## **UNO SUBDIVISION,** **PHASE TWO**

APPLICATION NUMBER 24 DATE December 6, 2007

REQUEST Subdivision

# SITE PLAN

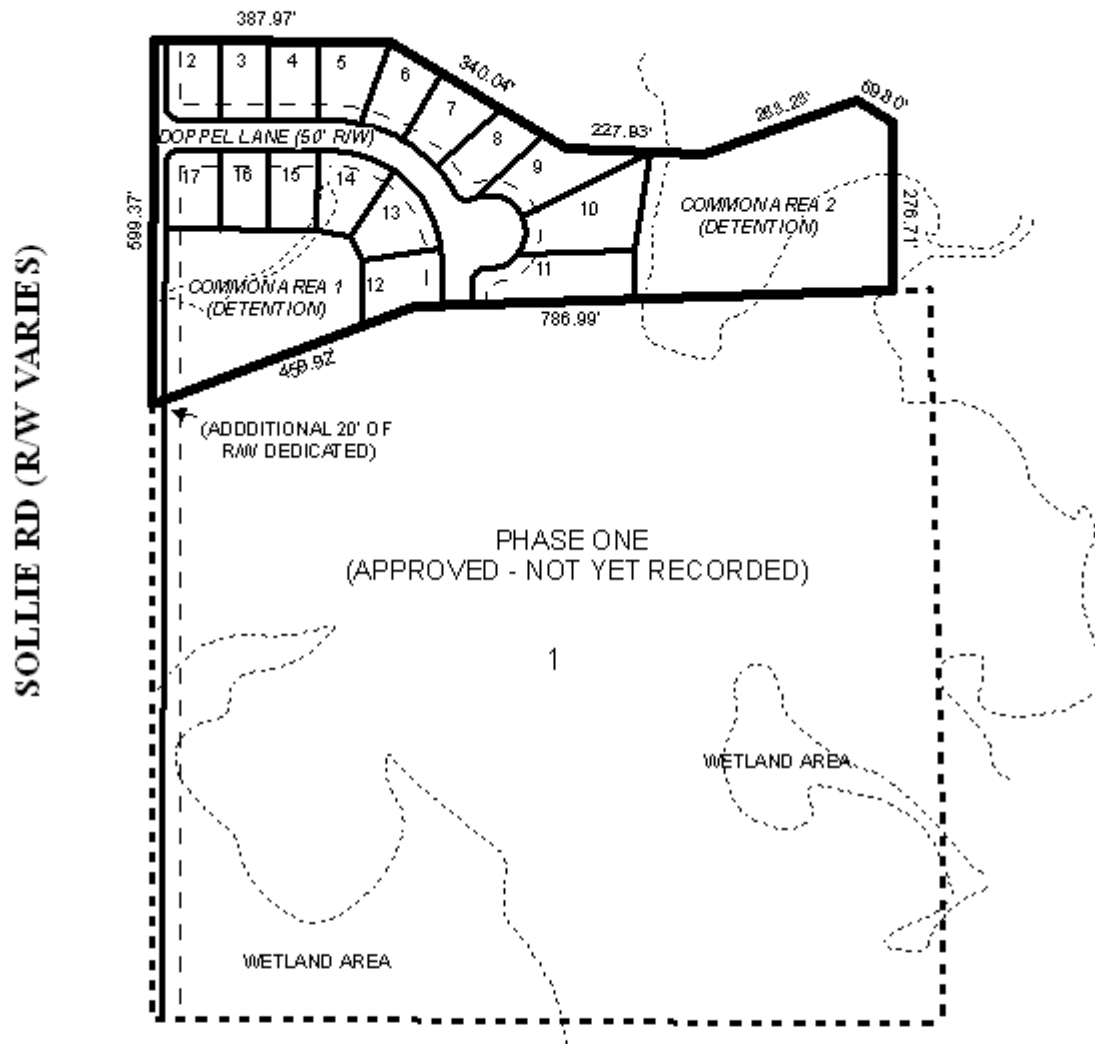
The site fronts Sollie Road, a major street as illustrated on the Major Street Plan, which is illustrated on the preliminary plat as variable right-of-way; therefore, the dedication of right-of-way sufficient to provide 50-feet as measured from the centerline of Sollie Road, should be required.

As the site has frontage on a major street (Sollie Road), and the development would provide 16-lots plus the secondary access from the proposed Crossroads apartment complex onto Sollie Road; the size, design and location of all curb-cuts must be approved by the Traffic Engineering Department. As stated in Traffic Engineering comments, the development should provide a traffic impact study prior to the approval and locations of the allowed curb cuts of the entire development to Sollie Road.

The site plan indicates the location of two common areas, which are typically used as detention basins, which would be required for the site due to new construction. A stormwater detention basin, sized to meet the requirements of the City's Storm Water Drainage Ordinance, must be indicated on the site plan if it is required. A note should be placed on the site plan, if approved, stating that maintenance of the common areas/detention basin, and any other common areas, are the responsibility of the development's property owners.

1. labeling of the lot with its size in square feet, or the provision of a table on the final plat with the same information;
2. placement of a note on the final plat stating that each lot is limited to one curb cut, with the size, location, and design to be approved by Traffic Engineering, and conform to AASHTO standards;
3. subject to the Engineering Comments *(It is the responsibility of the applicant to look up the site in the City of Mobile (COM) GIS system and verify if NWI wetlands are depicted on the site. If the COM GIS shows wetlands on the site, it is the responsibility of the*

*applicant to confirm or deny the existence of wetlands on-site. If wetlands are present, they should be depicted on plans and/or plat, and no work/disturbance can be performed without a permit from the Corps of Engineers. Must comply with all storm water and flood control ordinances. Any work performed in the right of way will require a right of way permit); and*

4. *subject to the Traffic Engineering Comments (Driveway number, size, location, and design to be approved by Traffic Engineering and conform to AASHTO standards. The traffic impact study performed during phase one has yet to be finalized. The comments provided for phase one of the development will apply to phase two as well. The site plan and the traffic impact study do not match as far as phasing of the development. The traffic impact study also shows 34% of the development traffic exiting from the north site access, but this a gated access and no reference is made to if it is an emergency access only, an exit only, or if can be used as and entrance and exit. This information should be provided and the traffic impact study changed to reflect the use if necessary. The developer will be responsible for constructing the recommended turn lanes into the site to City of Mobile standards. The traffic impact study did not provide a signal warrant analysis for the site. A signal warrant analysis will be required and the developer will be required to install a signal if one is warranted. The developer will also be required to provide a deceleration lane for the south site access).*
